5301
VHST/AR/PE
I/PJRU/MLD E/280-48
15th June 1983
Mr Unthank

RESTORATION OF FORMER BALLAST PIT
CHURCH LANE, WORMLEY

CHURCH LANE PIT
WORMLEY

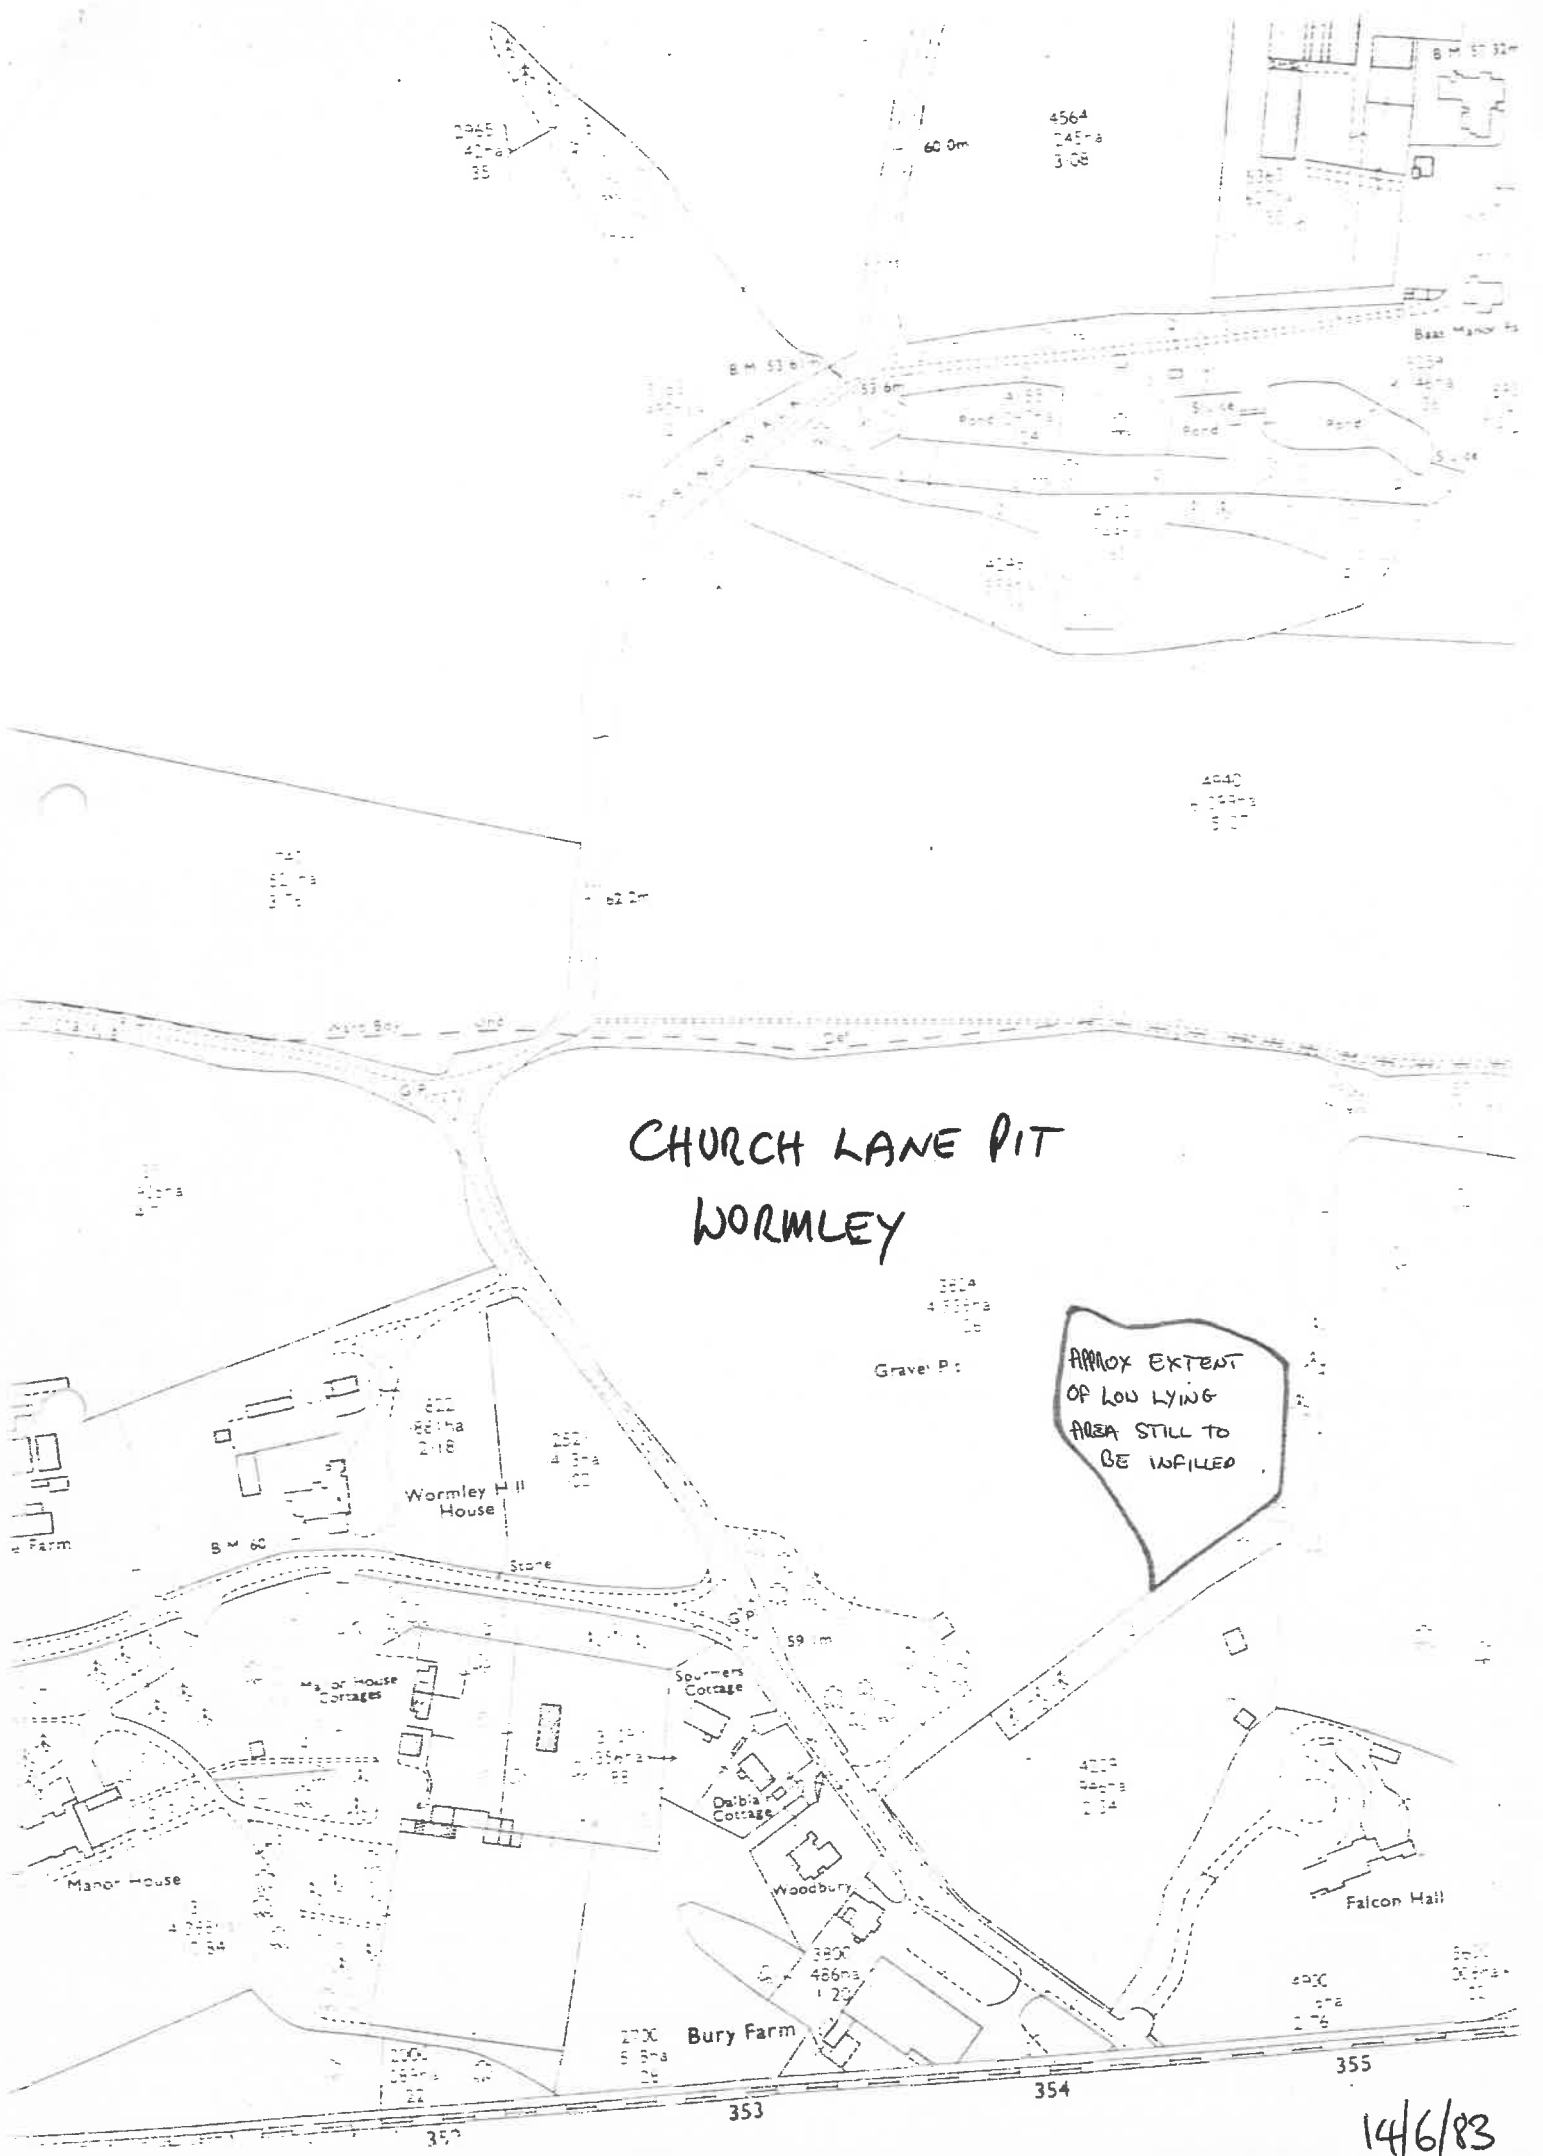
... As requested, I enclose a plan of the site showing the area yet to be filled. This will require a maximum of 2 metres of compacted fill graded out to original levels at the edge of the site.

Whilst infilling with waste materials continues, your client should make every effort to obtain sufficient clean soil to comply with the requirements of Paragraph 18 of the Site Licence and Condition 5 of the planning permission. These requirements are that the penultimate layer of cover over the waste should "to a depth of not less than 1 metre, be kept free of materials likely to interfere with the final restoration or subsequent cultivation" And the final layer be "composed of soil or soil-forming material at least 300 mm deep, which is readily capable of promoting plant growth."

APPROX EXTENT
OF LOW LYING
AREA STILL TO
BE INFILLED
